# Application for Certification (15-AFC-01)

**Puente Power Project (P3)**  
Oxnard, CA

**Responses to CEC Data Requests Set 4 (77-107)**

**FIGURE 84-1**

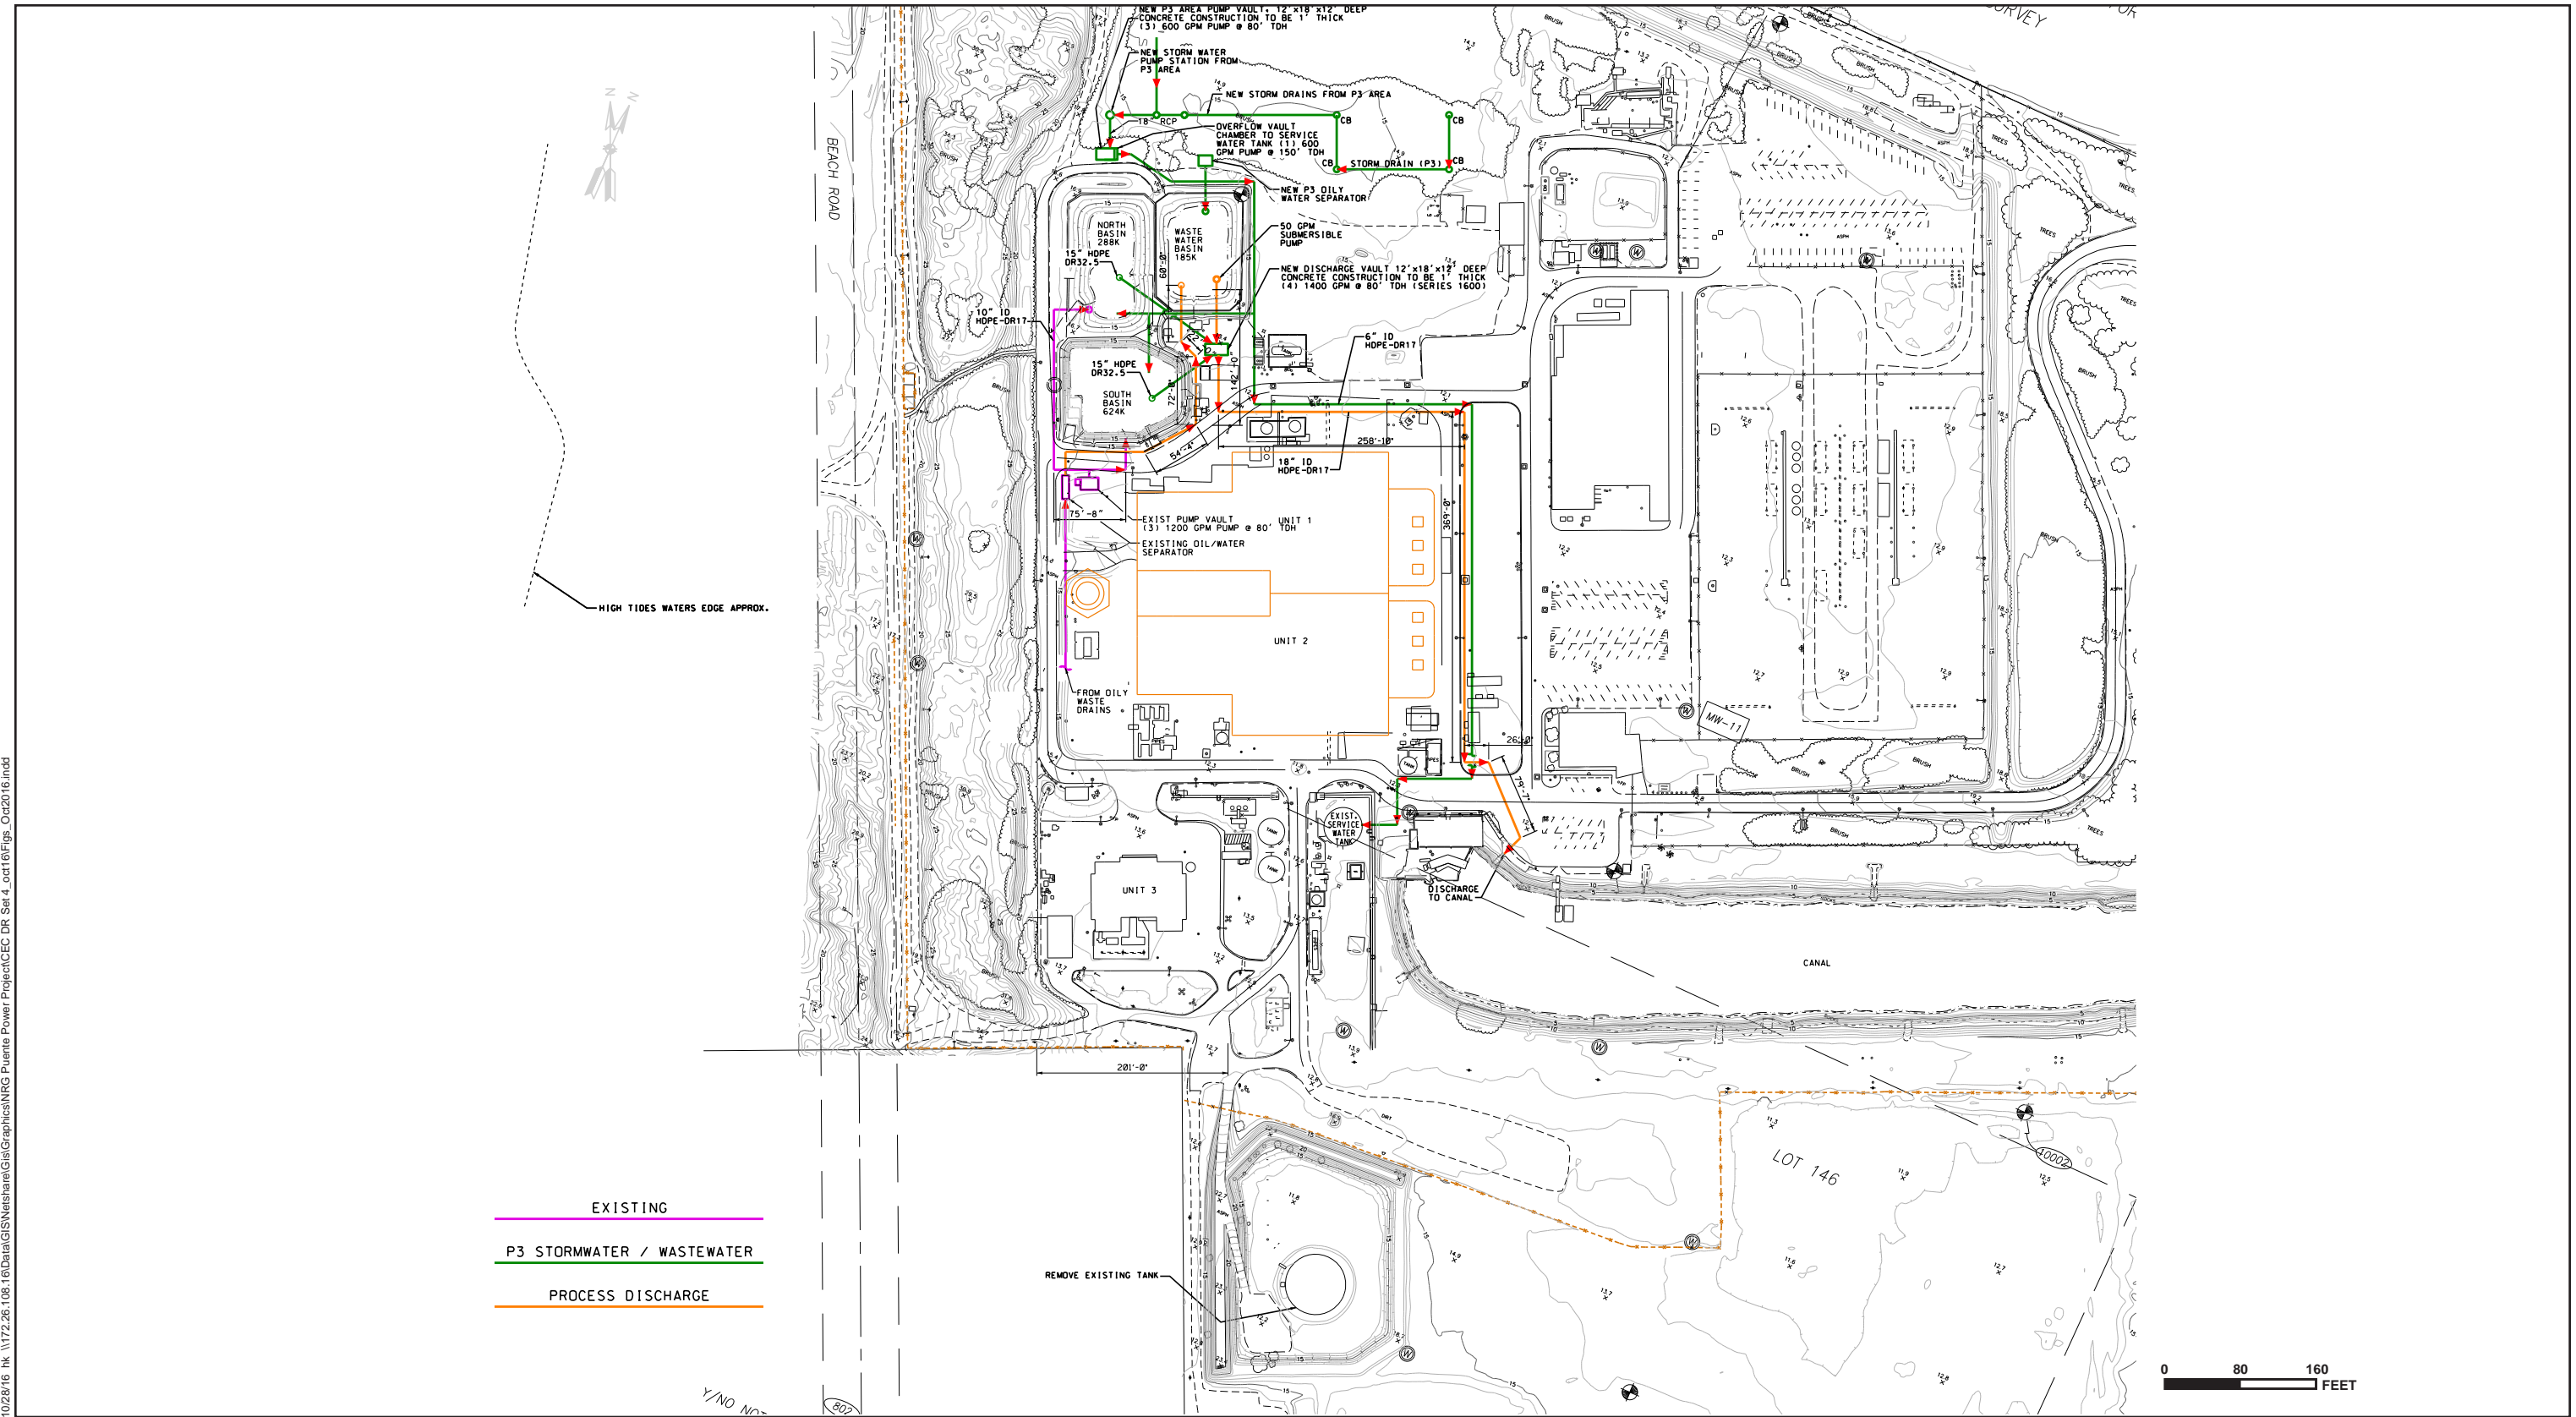
**84. Please provide impact acres for land cover types, including sandy beach, dune vegetation, and developed (outfall structure, wing walls and riprap).**

Potential impact acres for vegetation communities and land cover types by activities associated with the outfall removal, including an assumed 20-foot buffer zone, are presented in Table 84-1 and shown on Figure 84-1. It must be noted that, with the exception of the beneficial loss of manmade land cover type (i.e., open water habitat associated with the manmade channel, culverted water, and developed land cover), the impacts to vegetation communities and other land cover types are temporary in nature. It is anticipated that these temporarily disturbed areas will return to their pre-project condition following completion of demolition. Furthermore, once demolition of the existing outfall is complete and the beach and dune area is restored, the net effect will be an increase in natural vegetation communities and land cover types relative to current baseline conditions. The last column in Table 84-1 includes the net gain in natural land cover types as a result of the project.

FIGURE 91-1

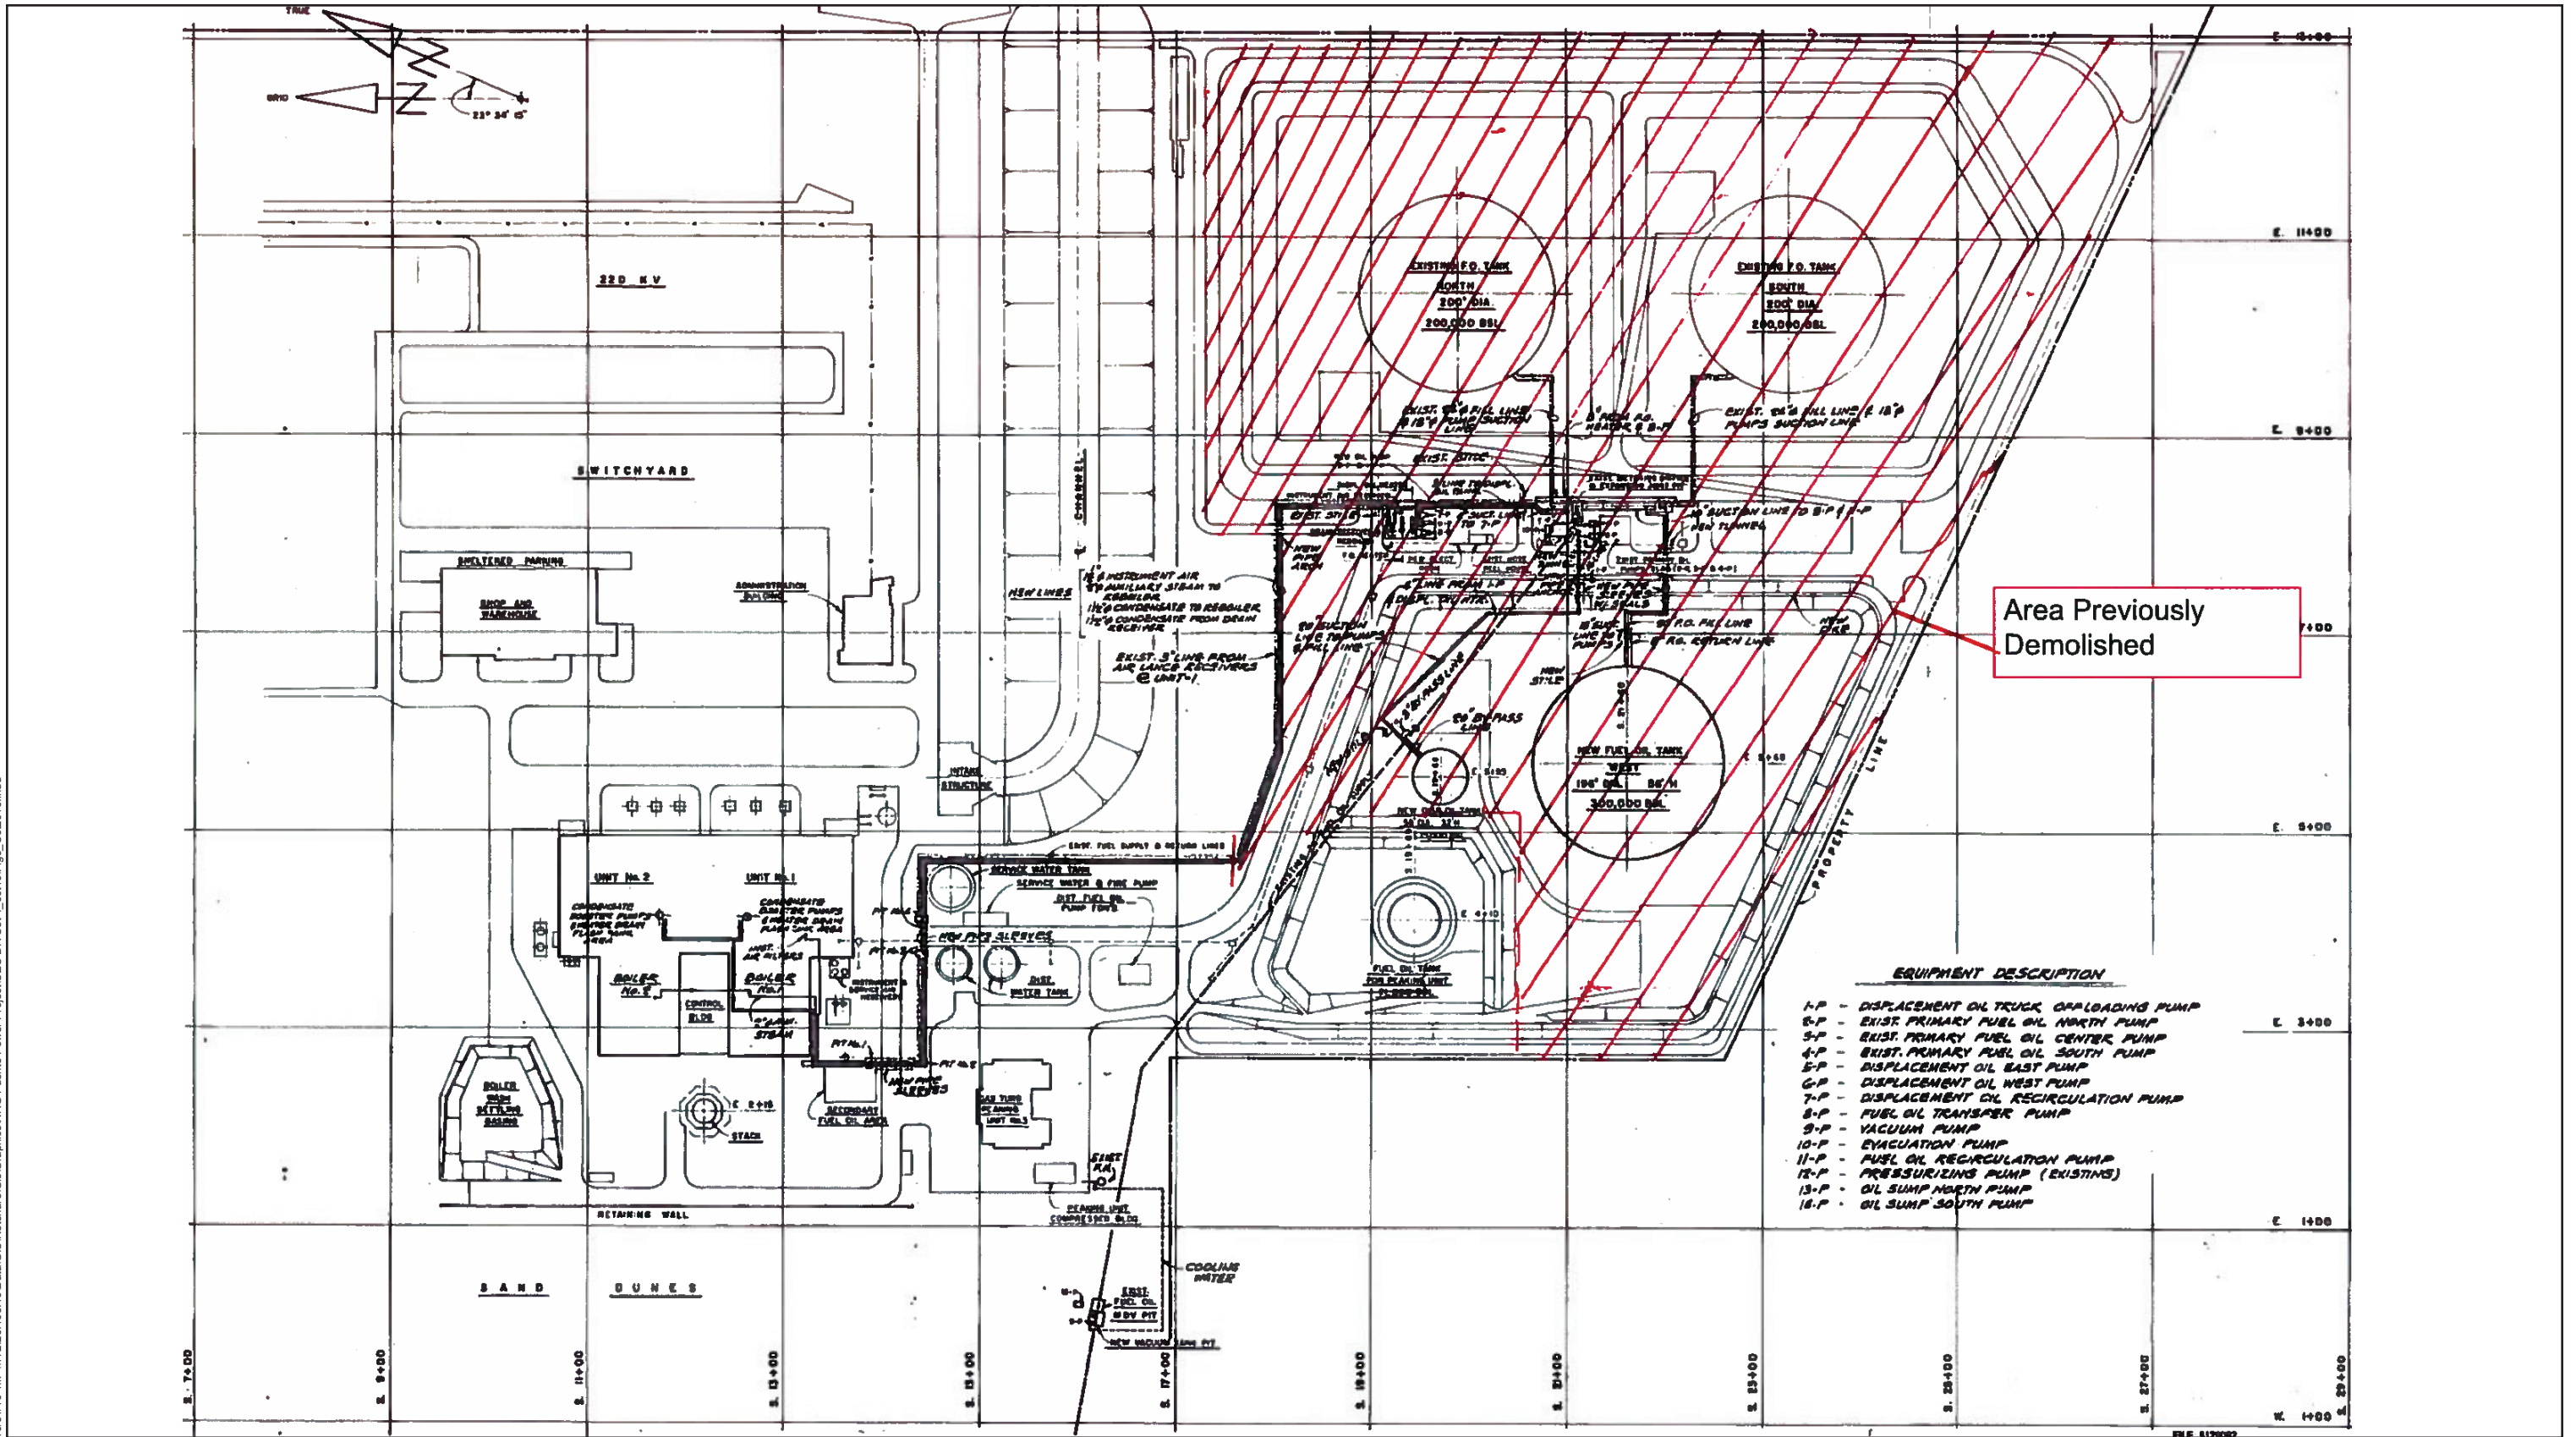
Section 2.1.1 of the Project Enhancement states that a new pump vault would be constructed west of the existing South basin to transfer storm water and wastewater from the basins to the Edison Canal. Figure 2-1 shows this new vault located at the outside edge of the existing access road. Staff is concerned that construction activities underneath the dunes at this location would result in damage that could take years to recover. Special effort should be made to protect the integrity of the natural dune ecology and structure.

Please see Figure 91-1 for the revised location of the proposed pump vault. The vault will now be on the eastern side of the basins, and will avoid the dunes.

Please see Figure 91-1 for the revised location of the proposed pump vault and associated pipes. The vault and pipes will now be on the eastern side of the basins, and will avoid the dunes.

**FIGURE 103-1**

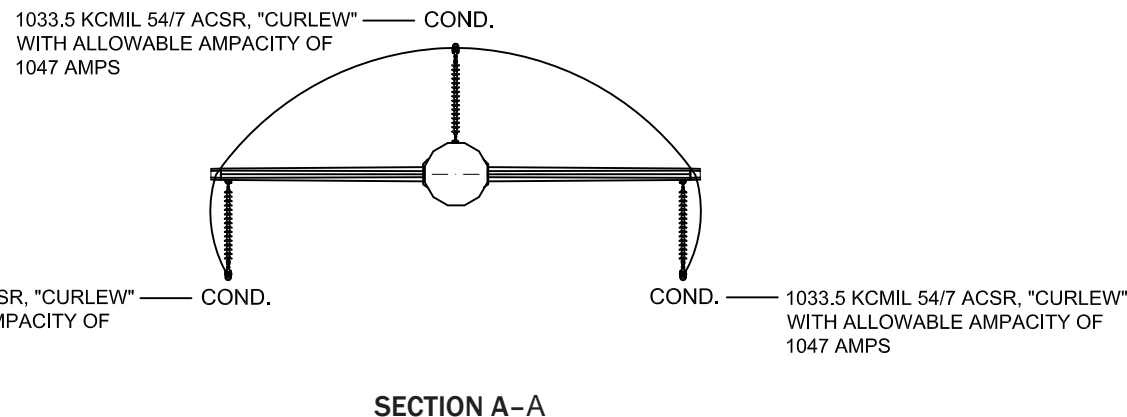
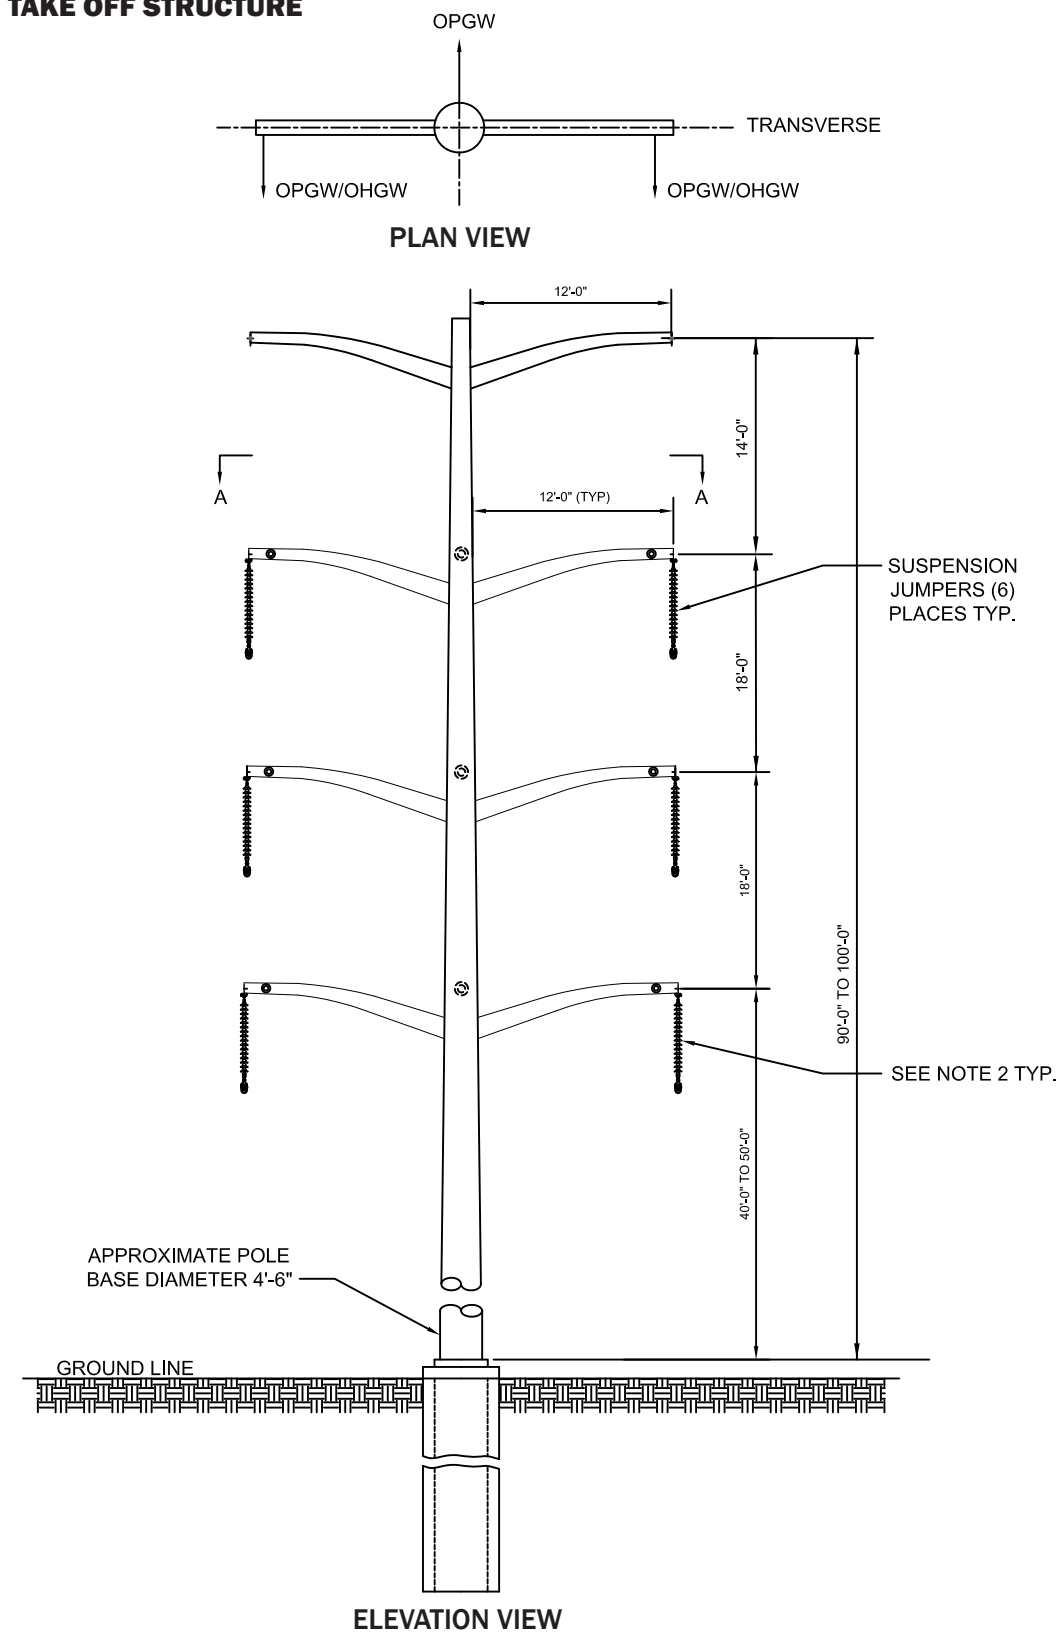
- 103. Provide a one-line diagram showing the entire generator tie-line route from the Puente project site to the SCE transmission structure across and east of Harbor Boulevard. Please indicate where the generator tie-line would end.**

Figure 103-1 provides a one-line diagram showing the entire interconnection tie-line route from the P3 site to the existing SCE transmission structure across and east of Harbor Boulevard. The point of interconnection is at the P3 220-kV take-off structure, as indicated on Figure 103-1.
